West Deer Township Planning Commission
Meeting Report for January 23, 2020

Project Name: **VRABEL LIGHTING PLAN AND 1-STORY BUILDING AT SPORTS COMPLEX - NO-OFFSEASON - RUSSELLTON**

Re: Brickyard Park Holdings
Revised Land Development Plan (plans revised January 20, 2020)
Lighting Plan (plans dated November 11, 2019)

PROPOSED BALLFIELD COMPLEX 1 STORY RESTAURANT

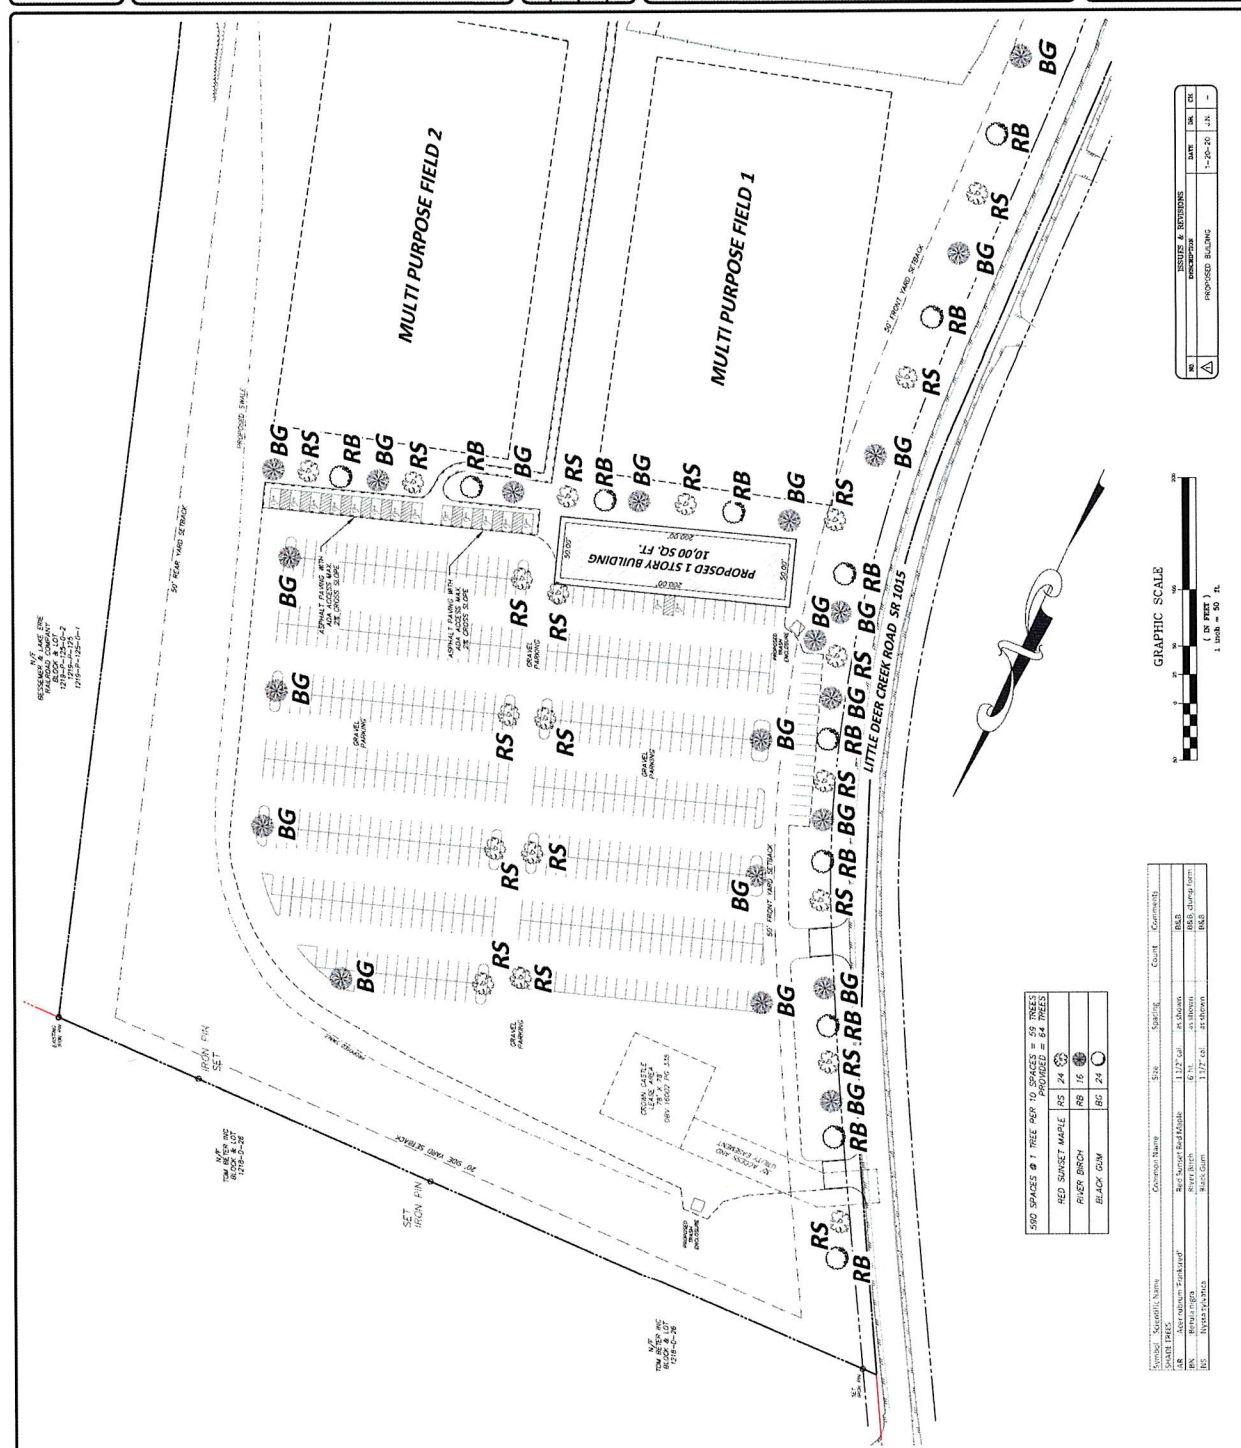
1. How will lines be painted on gravel ?
2. How do you delineate the island with trees and edge of lot with the gravel ? IE curb.
3. Where is the entrance and exit signage ?

4. Where are the light standards locations and fixtures? I see the photometric study but no conclusive outcome.
5. How will the standards be protected in a gravel lot ?

6. E & S drawing needed ? I see a swale indicated.
7. 590 parking Spaces. Will the existing/ new public toilet rooms be large enough to meet Allegheny County requirements for A-5 Assembly – outdoor sports events? (and the building itself? Is the travel distance to the restrooms within the ACHD allowed ?

8. Is the path to the various field locations and to the restrooms ADA compliant ? I don't see an indication of this ?
9. Doesn't Penn Dot need to be involved for the turning radius onto the state road ? Is a traffic study indicated ?

10. Does this need to be looked at for noise issues ?
11. Is the electric service available adequate to cover all the lighting for the fields building and parking ?

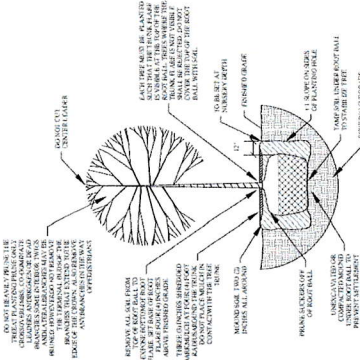
590 SPACES @ 1 TREE PER 10 SPACES = 59 TREES PROVIDED = 64 TREES
